Figure 8: Paths in Whiskey Creek Plan Change and connections to the Mangaone Stream

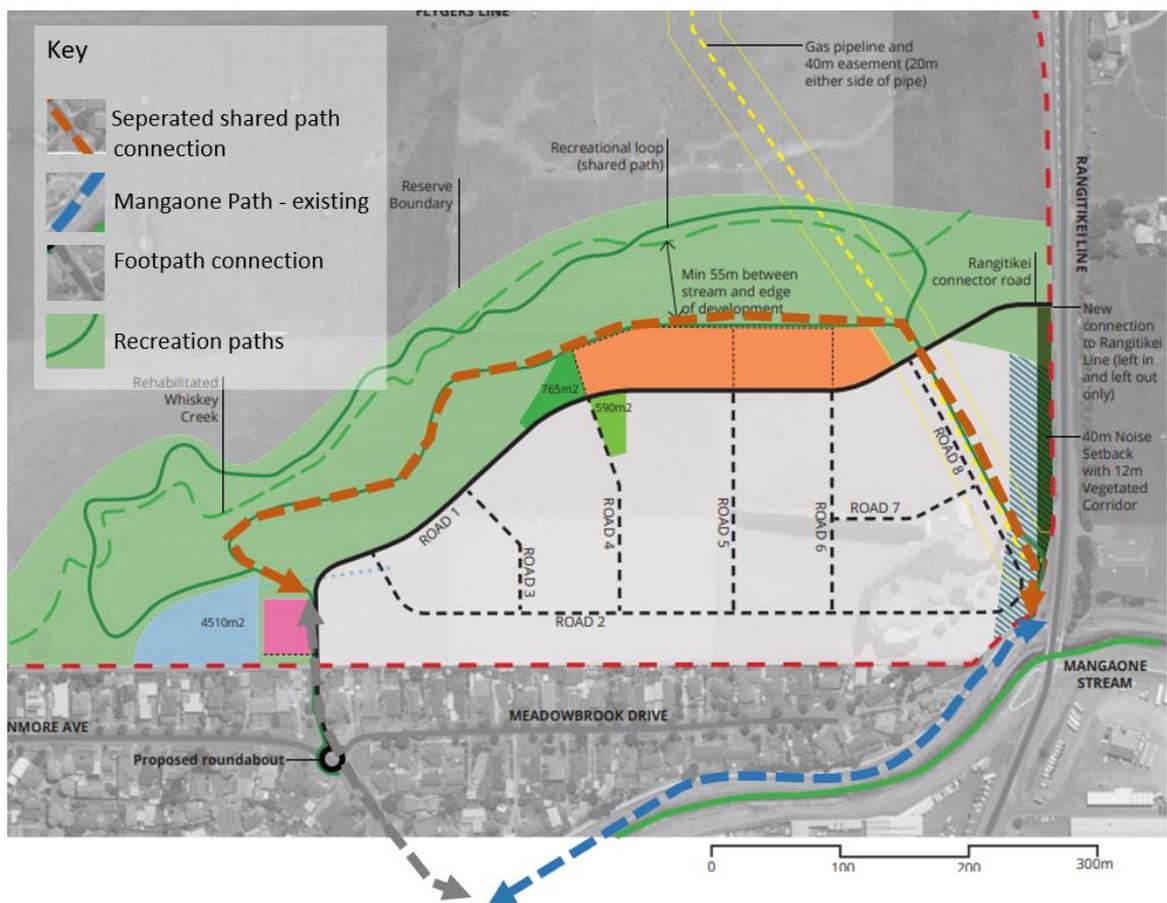
- 6.3 The connections to the Mangaone Stream path are a benefit, both for active transport and recreation.

Figure 9: Recreation loops created

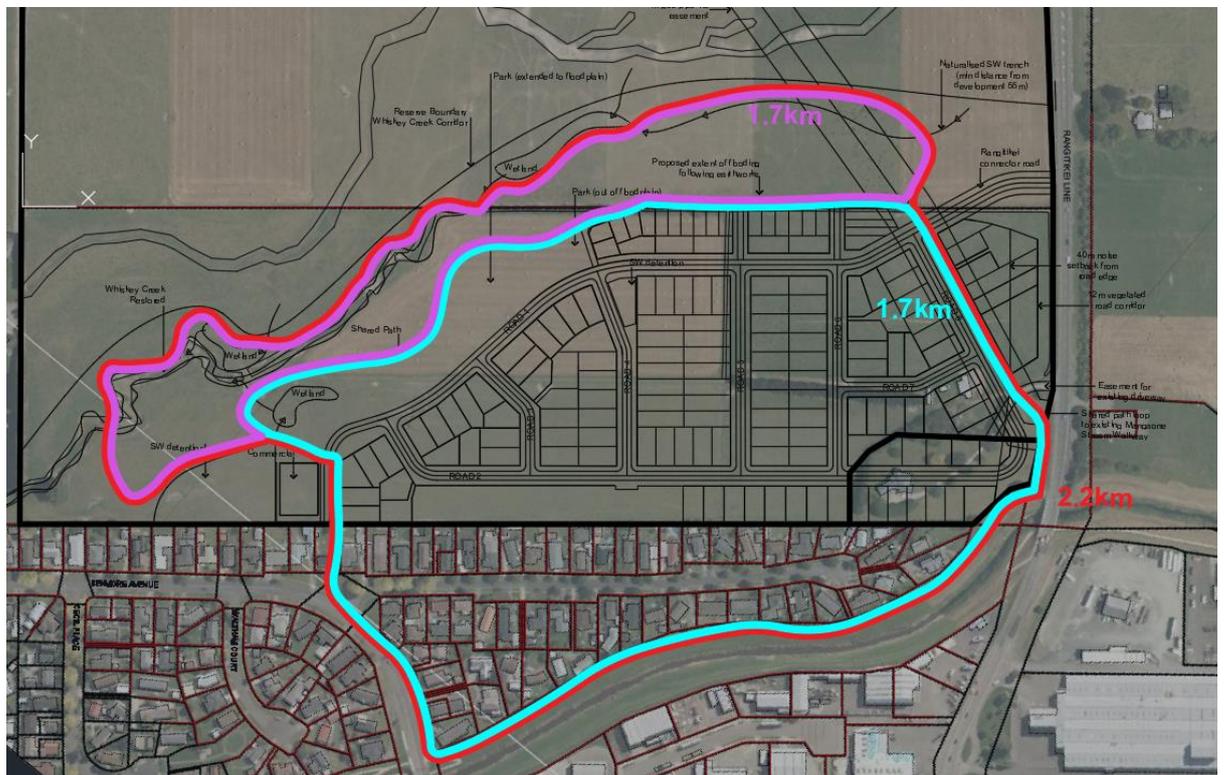
- 6.5 It is expected a loop or loops will be attractive to the community.
- 6.6 The Transport division advise that their requirement is for the a shared path to be created shown in Figure 9 as the dashed orange line.
- 6.7 Programme 1861 in the 2021/31 Ten Year Plan assumes construction of 750m of new recreation paths from the Parks and Reserves budget³ of \$298,000⁴. This budget was based on an earlier iteration of the structure plan.
- 6.8 The current design increases the walkway length by about 250m. This is shown Figure 9 as the narrow solid green line in Figure 9.
- 6.9 If the plan change is approved in its current form, provision for the additional length will need to be in the 2024/34 Ten Year Plan. This will increase costs by:
- \$25,000 to \$40,000 path construction costs including additional stream crossings
